#### **SERVICE BULLETIN**

**SB00.09**

Machines/Models: AB38

**PURPOSE:** Enhance performance of the Main Hydraulic Manifold Cartridge Valves.

Figure 1

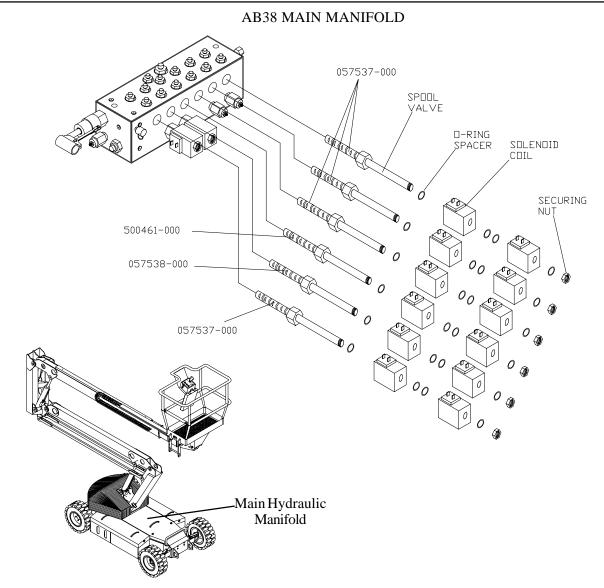
**OPERATION REQUIRED:** Replace the Cartridge Valves on the Main Hydraulic Manifold.

1 each - Cartridge Valve (057538-000) (S270 Valve Identifier)

4 each - Cartridge Valve (057537-000) (S271 Valve Identifier)

1 each - Cartridge Valve (500461-000) (S272 Valve Identifier)

# NOTE: Verify that the correct part number valve is being installed per Fig 1.

- 6. Install the Supplied Cartridge Valve and torque to 25-30 Ft. Lbs. (34-41 Nm).
- 7. Install the Valve Coil, Spacer O-Rings and Knurled Securing Nut removed in step 4 and tighten finger tight.
- 8. Repeat the above operation for all Cartridge Valves to be changed.
- 9. Reinstall chassis cover and secure.
- 10. Perform the Pre-Operation and Safety Inspection as instructed in the Operator Manual to ensure proper operation of machine.
